Metropolitan Development Commission Regional Center Hearing Examiner (April 11, 2024) Meeting Agenda

STAFF REPORT

Case Number	2023-REG-027 (Amended)
Address (approx.)	1140 Dr. Martin Luther King, Jr. Street
Location	Center Township, Council District #12
Petitioner	Indianapolis Public Schools
Zoning	SU-2 (RC)
Request	Regional Center Approval to provide for demolition of an existing stadium and construction of a proposed athletic field.

Aerial of site and surrounding area (top); site plan

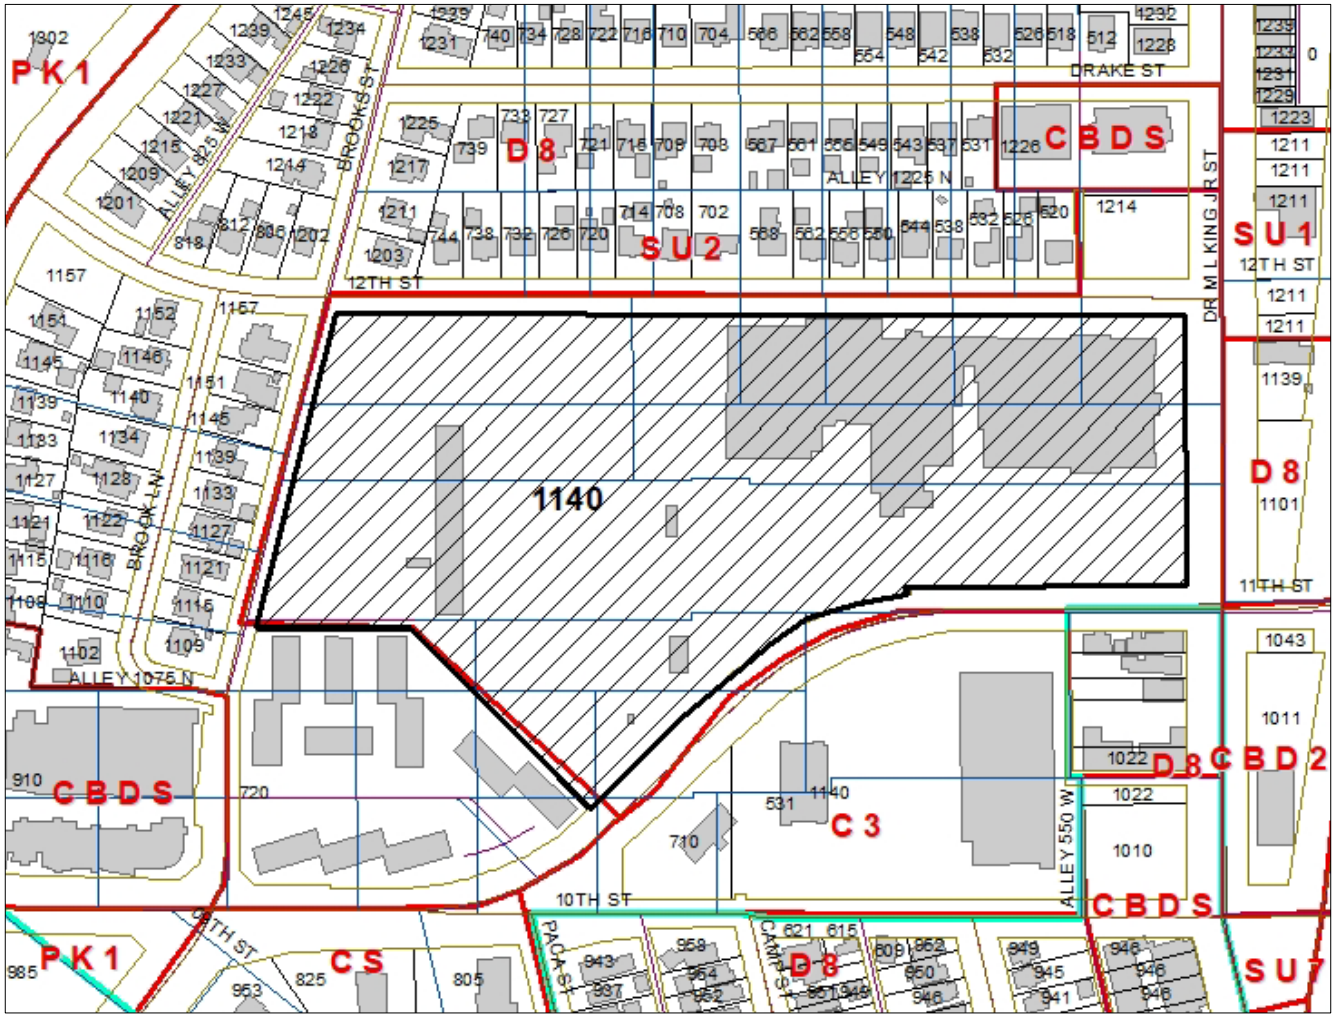
This request would demolish the existing sports stadium and construct a new sports field, with soccer, football, track, and field markings and facilities. The sports field would have an east-west orientation. The revised site plan indicates that the stadium and the requested bus parking area have been removed from the original proposal. The petitioner verbally indicated that these facilities would be part of a future request. There are no plans for the historic school building.

Review of the Guidelines against the submitted plans reveals the request would meet the Guidelines.

Staff **recommends approval** of the Regional Center Approval petition, with the following condition:

The elevations of the fencing shall be submitted for staff review and approval prior to installation.
